August 28, 1995

SUBJECT: LaSalle County Nuclear Power Station Units 1 and 2
Application for Amendment of Facility Operating Licenses
NPF-11 and NPF-18, Appendix A, Technical
Specifications, and Exemption to Appendix J of 10CFR50
Regarding Elimination of MSIV Leakage Control System
and Increased MSIV Leakage Limits
NRC Docket Nos. 50-373 and 50-374

DESCRIPTION AND SAFETY ANALYSIS OF PROPOSED CHANGES TO APPENDIX A, TECHNICAL SPECIFICATIONS OF FACILITY OPERATING LICENSES NPF-11 and NPF-18

FIGURE 1

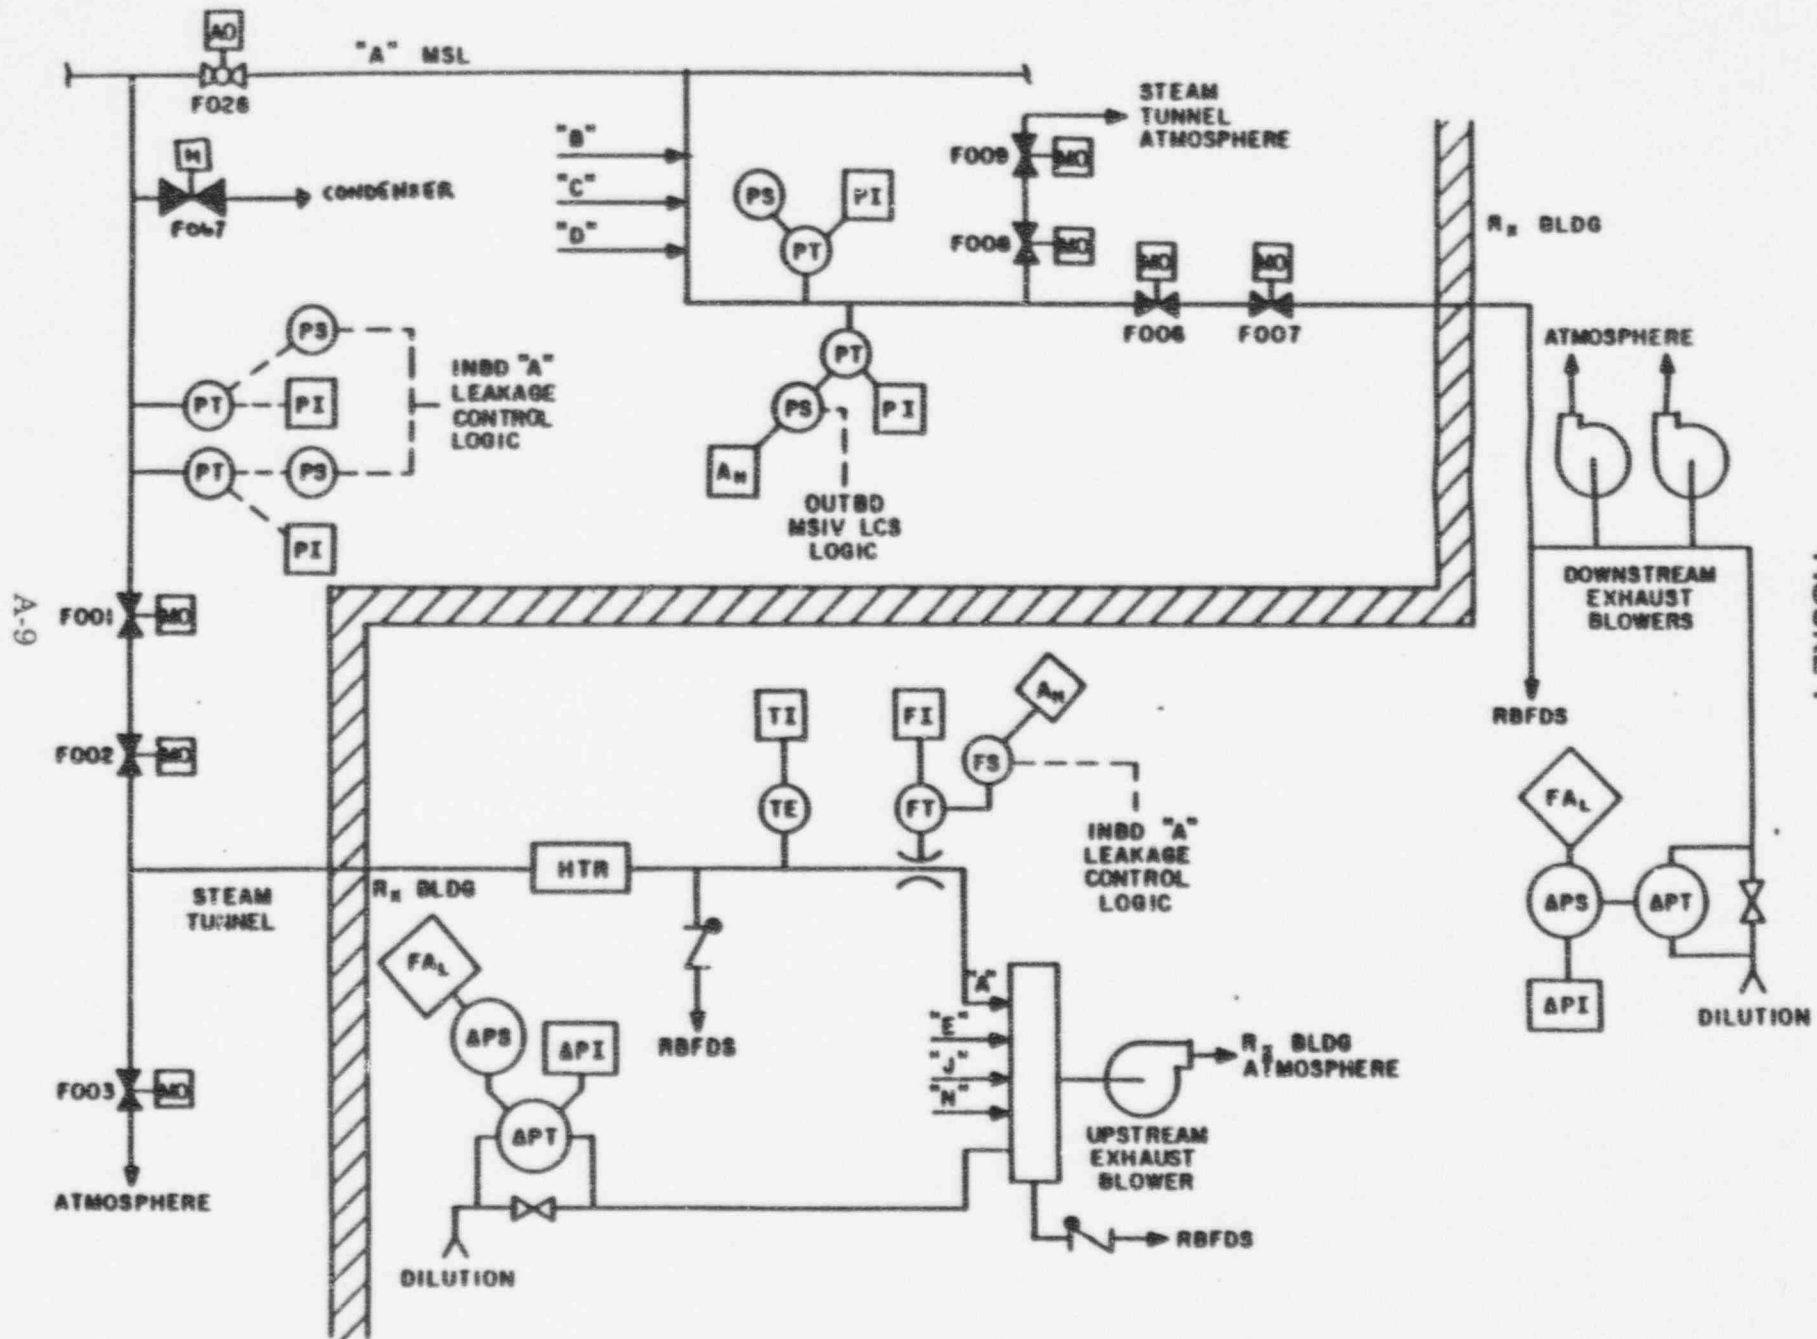
ComEd proposes to replace the use of the MSIV LCS for processing MSIV leakage with the main steamlines, main steamline drains, and the main condenser. Because this arrangement provides a higher capacity for processing leakage than the existing LCS, this request would also change the allowable MSIV leakage from 100 scfh for all four main steam lines to 100 scfh per steam line (400 scfh for all four main steam lines).

The MSIV LCS provides an alternate flowpath for MSIV leakage to secondary containment, where it can be treated by the Standby Gas Treatment system and released in a controlled manner through the stack. A diagram of the LCS at LaSalle is shown in Figure 1.

With the deletion of the MSIV LCS, which involves cutting and capping all piping connecting the MSIV LCS to the Main Steam system, MSIV leakage will pass from the outboard MSIV, through the Main Steamlines, Main Steamline Drains and into the condenser. The large volume in the main condenser holds up fission products that escape through the MSIVs, limiting release to the environment. This alternate pathway is more reliable than the existing LCS since less equipment is employed. The alternate pathway also has a much higher capacity for processing leakage than does the MSIV LCS, with a capacity of only 100 scfh. In addition, the MSIV LCS will only operate at less than 35 psig reactor vessel steam dome pressure, whereas the alternate pathway is independent of reactor pressure.
